[Home](#) > [Development Assessments](#) > [Major Project Assessments](#)

Vickery Coal Project

VICKERY COAL PROJECT
FIGURE ES-2
 Project Overview -
 Mining Area

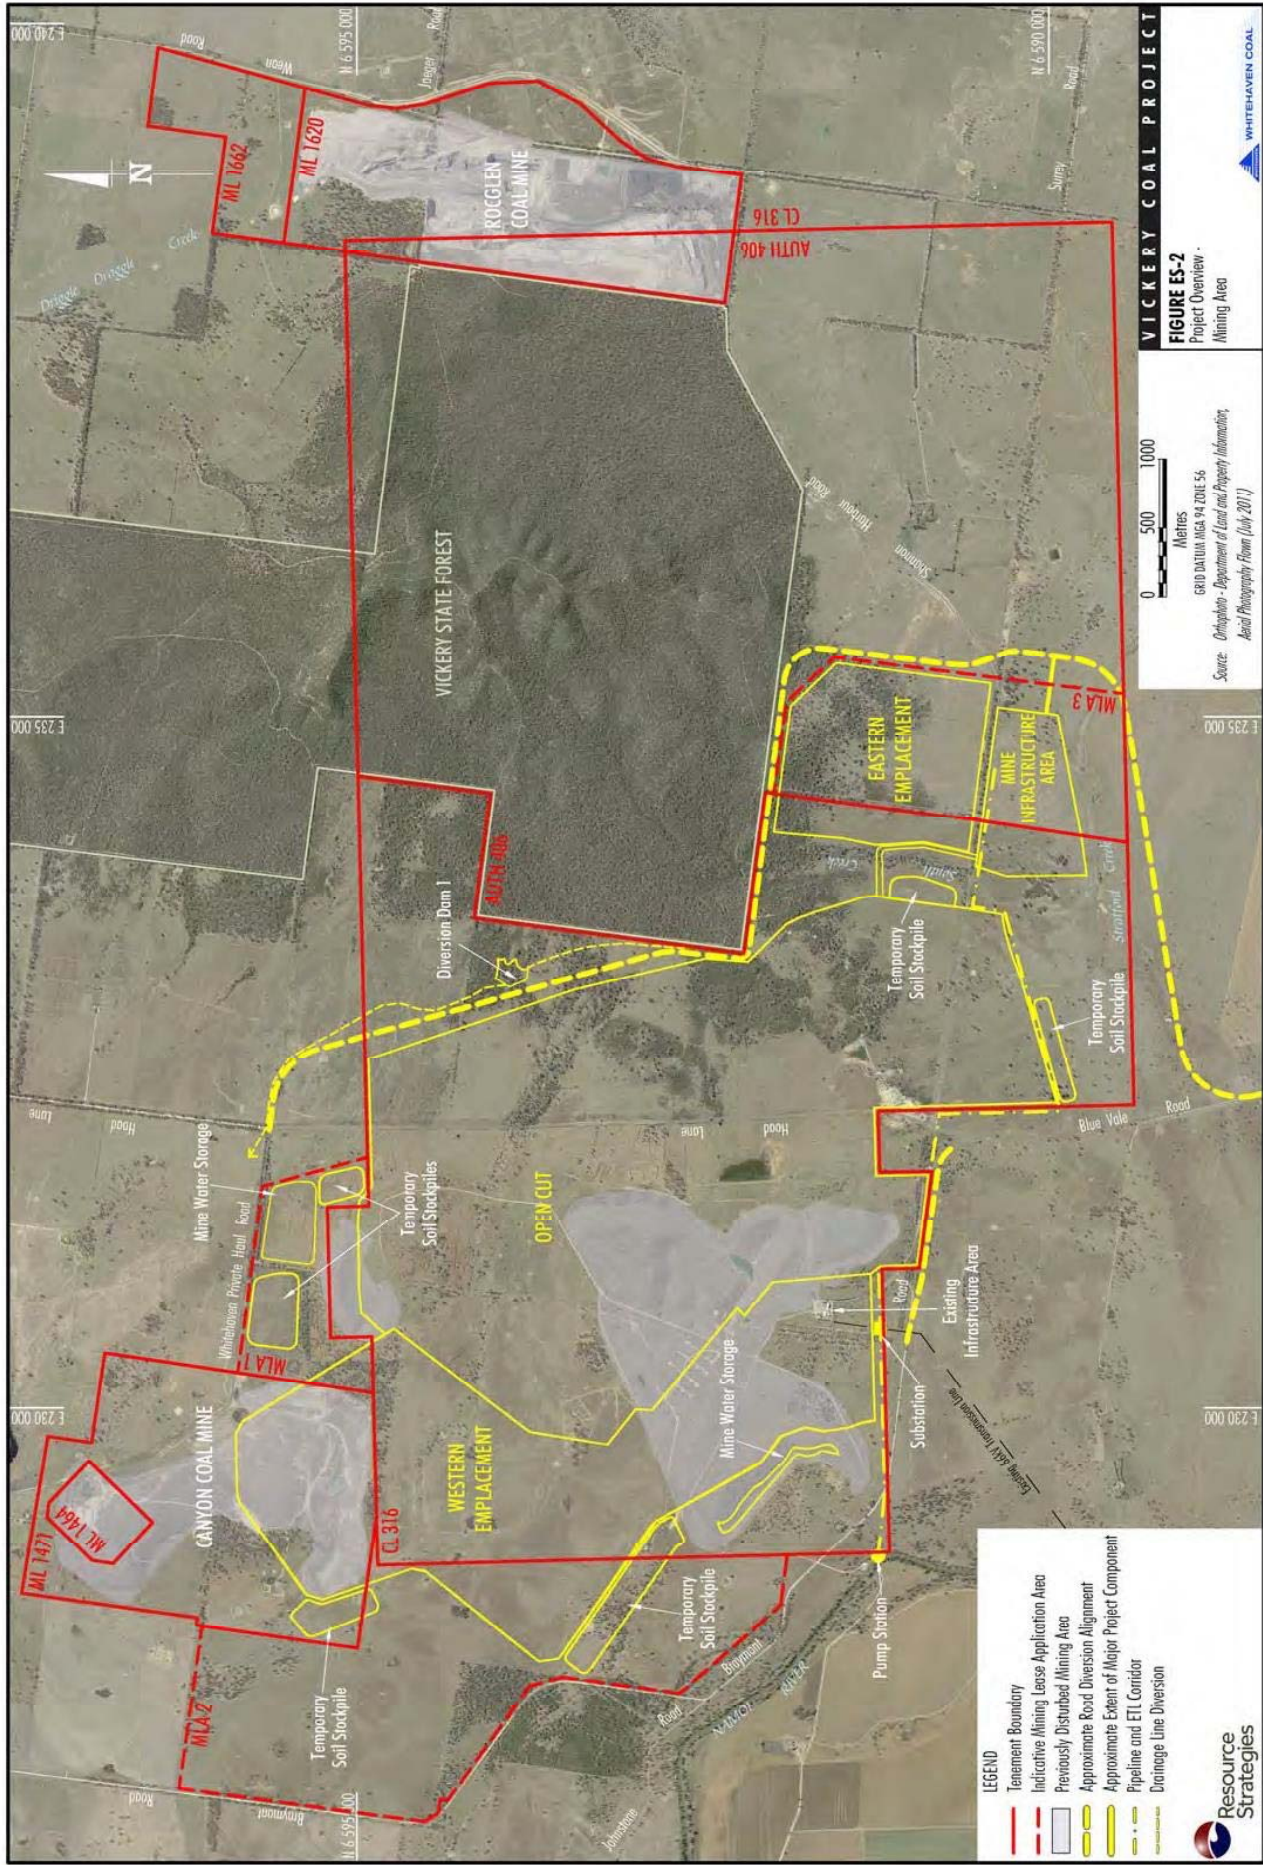
3. The proposed rerouting of the Bluevale Road (See Figure ES2 - Attachment C) will further exacerbate the water diversion issue by changing the path of small runoff flows during large rainfall events.
